Illustrating some TDECQ comments

Piers Dawe

Not all maximum-TDECQ signals are equal

TDECQ map

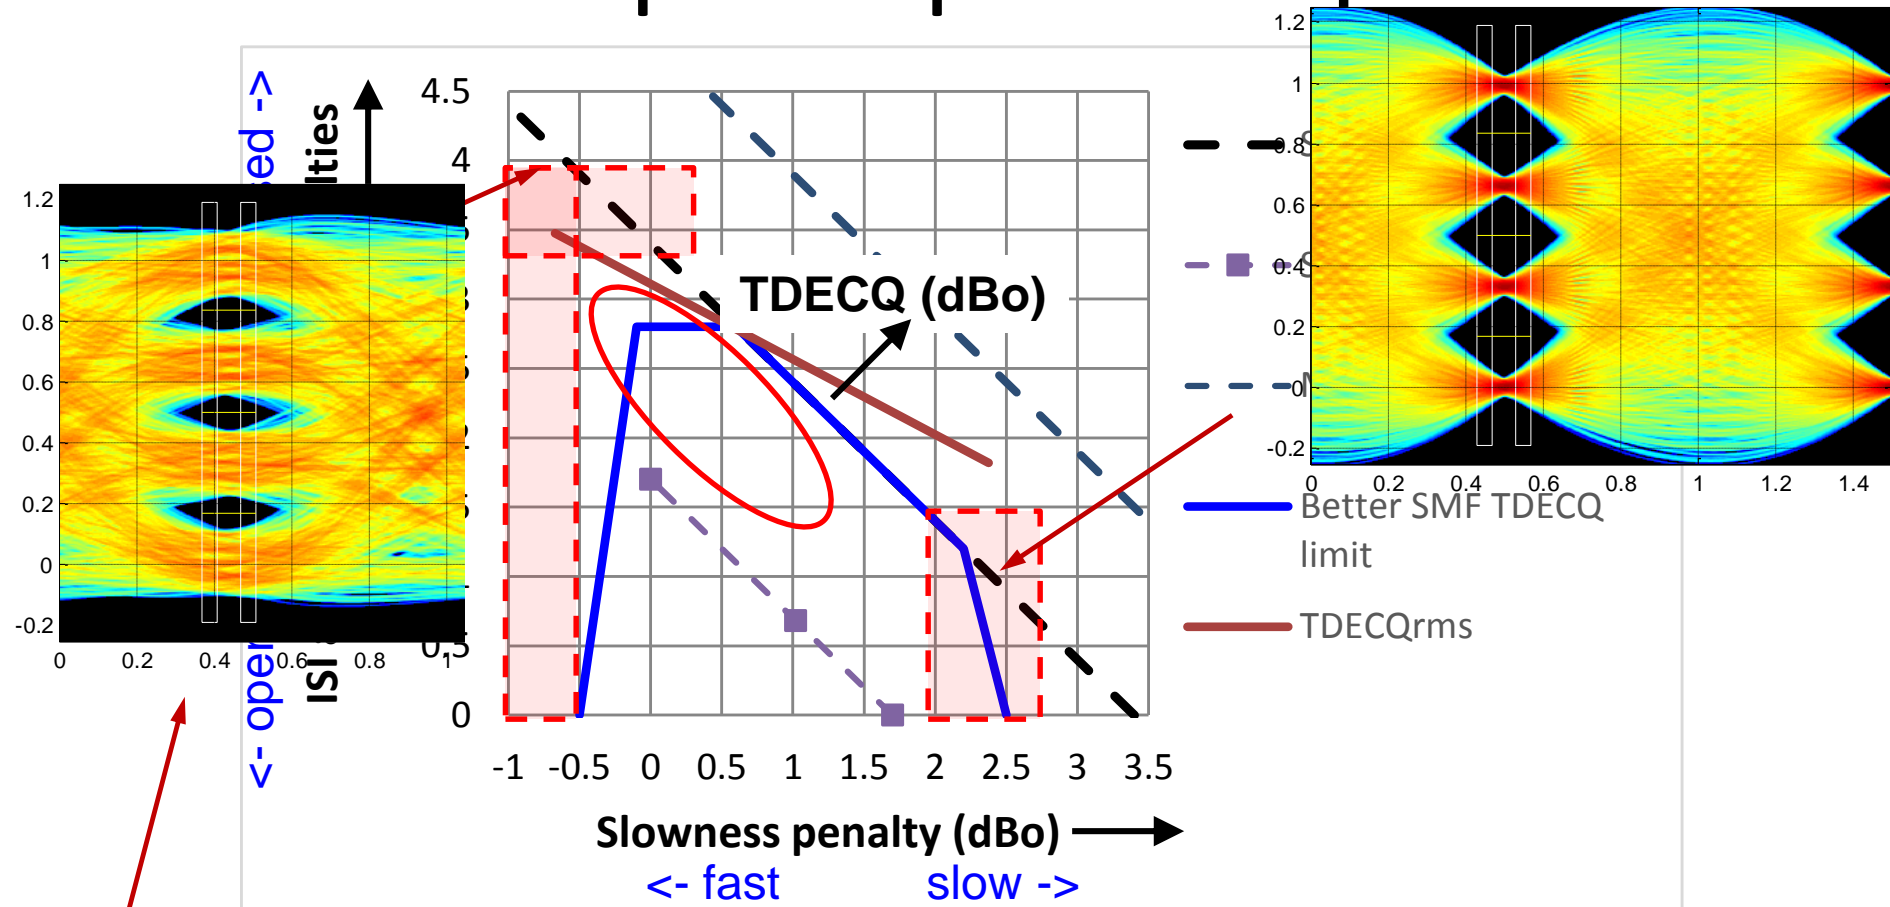
Bound the left side (too much emphasis)

- *CI 121 SC 121.8.5.4 P 136 L 20 # r02-7* **TR**
- A much wider range of signals are allowed to be transmitted than are covered by SRS (required to be received).

- At present it is allowed to make a transmitter with a noisy or distorted signal, use heavy emphasis to get it to pass the TDECQ test, yet a compliant receiver that passes SRS would not need to receive it. The range needs to be bounded on the left hand side of the maps in *dawe_3cd_01a_0318* and *dawe_032118_3cd_adhoc* so that the receiver design can be bounded in terms of having to "invert" heavily over-emphasised signals, and the gap between possible signals and SRS closed or narrowed.

Bound the top (irreparably bad)

- *CI 121 SC 121.8.5.3 P 136 L 14 # r02-8 TR*
- A much wider range of signals are allowed to be transmitted than are covered by SRS (required to be received).

- At present it is allowed to make a transmitter with a noisy or distorted signal and use emphasis to get a "noise enhancement credit" to pass the TDECQ test, yet the eye closure is more than the TDECQ limit and a compliant receiver that passes SRS would not need to receive it. The range needs to be bounded on the top side of the maps in *dawe_3cd_01a_0318* and *dawe_032118_3cd_adhoc* so that the receiver design can be bounded in terms of resolution and patterning, and the gap between possible signals and SRS closed or narrowed.

- The remedy doesn't directly outlaw over-emphasised signals, but gives them worse TDECQ scores.
- D3.1 comment 35
- *Suggested Remedy*
- This remedy lets the transmitter designer use reasonable amounts of emphasis, balancing his own transmitter bandwidth and the reference receiver front-end bandwidth.

- After saying where the largest magnitude tap coefficient is, add **"The tap coefficients are constrained so that the sum of the other four tap coefficients is less than zero."**

- **Similarly in clauses 122, 124.**

- The first remedy has the disadvantage that errors in OMA measurement degrade its accuracy.
- D3.1 comment 35
- *SuggestedRemedy*
- Either:
 1. **Limit TDECQ $-10 \cdot \log_{10}(C_{eq})$ to ≤ 2.8 dB.**

- **or:**
 2. Define **TDECQ_{rms}** = $10 \cdot \log_{10}(A_{RMS}/(s \cdot 3 \cdot Q_t \cdot R))$ where A_{RMS} is the standard deviation of the measured signal after the 13.28125 GHz filter response (before the FFE), Q_t and R are as already in Eq 121-12. s is the standard deviation of a fast clean signal with OMA=2 and without emphasis, observed through the filter response (0.6254 for 13.28125 GHz).

- **Limit 3 dB.**
- Either remedy to apply to **all PMDs** that use TDECQ in Section 8, although it would not matter much for 400GBASE-FR8 if the over-emphasis limit (see another comment) is in force.
